Access Compliance Report

Public Rights-of-Way

(Curb Ramps)

Intersection ID: 53886	Main Street: PAW_VALLEY_LN	Cross Street: PAW_VILLAGE_RD	Location:	N
ADA ID: CC99110F35A6	Ramp Type: BlendTrans1	Initial Pass/Fail: Fail	Overall Compliance: No	Severity Score: 10

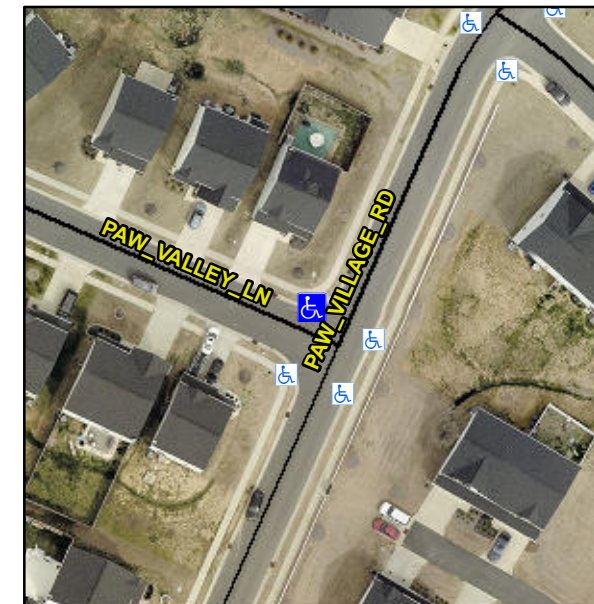
Not Found, R304.5.1, R304.5.3

Compliance	Description	Data	Compliance	Description	Data
N/A	Ramp Length (in)	48.0	Yes	BlendTrans Slope (%)	2.7
No	Ramp Width (in)	47.5	No	BlendTrans XSlope (%)	4.1
N/A	Flare Type LT	N/A	N/A	Flare Type RT	N/A
N/A	Flare Slope LT (%)	N/A	N/A	Flare Slope RT (%)	N/A
N/A	Flare Traversable LT?	N/A	N/A	Flare Traversable RT?	N/A
N/A	Landing Length (in)	N/A	N/A	DWS Provided?	N/A
N/A	Landing Width (in)	N/A	N/A	DWS Contrast?	N/A
N/A	Landing Slope (%)	N/A	N/A	DWS Length (in)	N/A
N/A	Landing X Slope (%)	N/A	N/A	DWS Full Width?	N/A
N/A	Landing Curb? (Y/N)	N/A	N/A	DWS Offset (in)	N/A
N/A	Shared Landing?	N/A			
N/A	Gutter Ponding?	N/A	N/A	Gutter Slope (%)	N/A
N/A	Gutter Lip Ht (in)	N/A	N/A	Gutter X Slope (%)	N/A
N/A	Painted X Walk1?	No	N/A	Painted X Walk2?	No
	X Walk 1 Direction	To SW		X Walk 2 Direction	To SE
	X Walk 1 Width (in)	N/A		X Walk 2 Width (in)	N/A
	X Walk 1 Slope (%)	2.8		X Walk 2 Slope (%)	6.7
	X Walk 1 X Slope (%)	7.0		X Walk 2 X Slope (%)	0.6

Remove & Replace Curb Ramp With Two New Directional Ramps or Equivalent.
